GFCI Breaker and Decal Installation

Bulletin Type:	Recall	Publication Date:	May 2025
Bulletin #(s):	25V-285	Make(s):	Jayco, Entegra Coach
Job Code(s):	9903629	Model(s):	Terrain 19YG, Launch 19YG
Flat Rate(s):	9903629 .50 HR GFCI Breaker and Decal Installation	Model Year(s):	2025

Incident:	Standard outlet in the kitchen without GFCI protection
Affected Units:	2025 Jayco Terrain 19YG and 2025 Entegra Coach Launch 19YG
Parts Kit: 25V-285	Parts Kit #: 25V-285
	1 EA – BREAKER,CKT GFCI 20A 120V SIEMENS Q SER 1 EA – DECAL,120V LD CTR 1.13X10.00 "S1" 2025 VER 2
Misc. Tools & Supplies:	Screw Gun with square head & flat blade bit.
Parts Return Information:	N/A

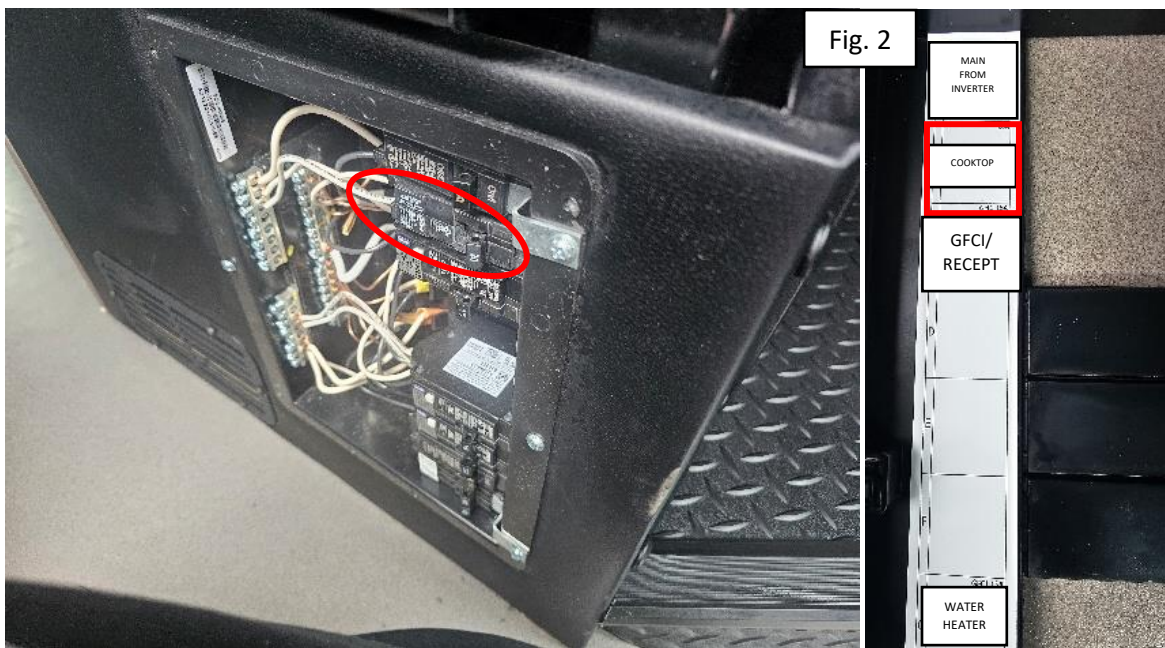
1. Use a screw gun and square head bit to remove the cover on the load center, there should be 4 fasteners . (Figure 1)

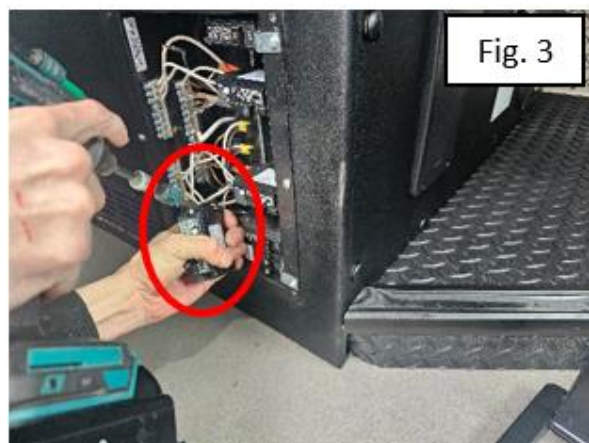
2. With the cover removed, identify the breaker for the "Cooktop". (Figure 2)
 - a. **Note: It should be the second breaker from the top of the load center. It will correspond to the decal attached to the load center lid.**

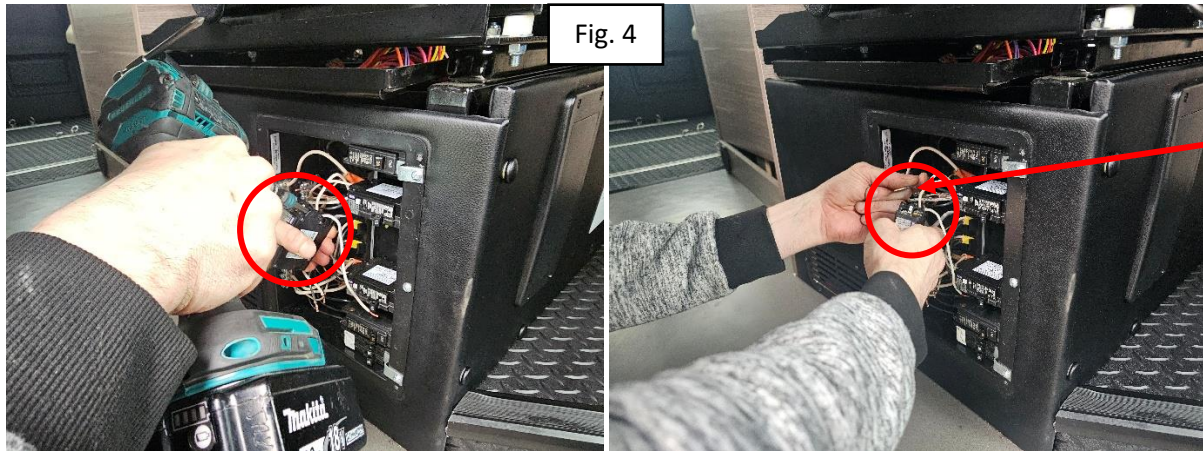
3. Use a flat blade bit to pop the breaker out of the housing.
4. With the breaker out, disconnect the existing Black wire. (Figure 3)

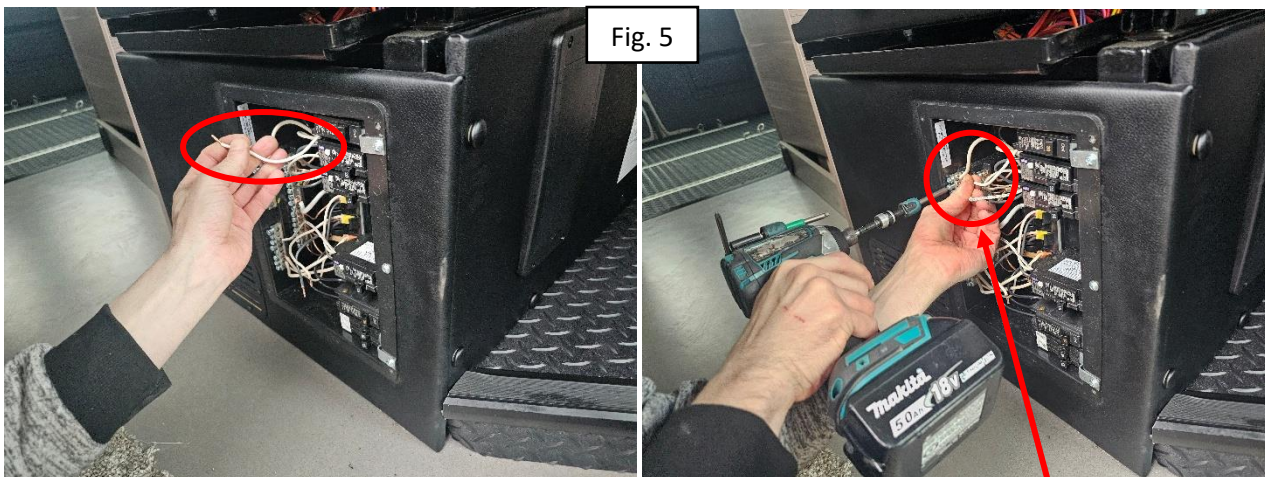
- ⚠ 5. Take the new GFCI breaker, unwind the white neutral wire, then connect the existing black wire to the new GFCI breaker.
- a. **Note: It is CRITICAL you torque this connection to 25IN-LBS.** (Figure 4)

6. Re-secure the breaker into the housing, in the load center, where the original was removed from.
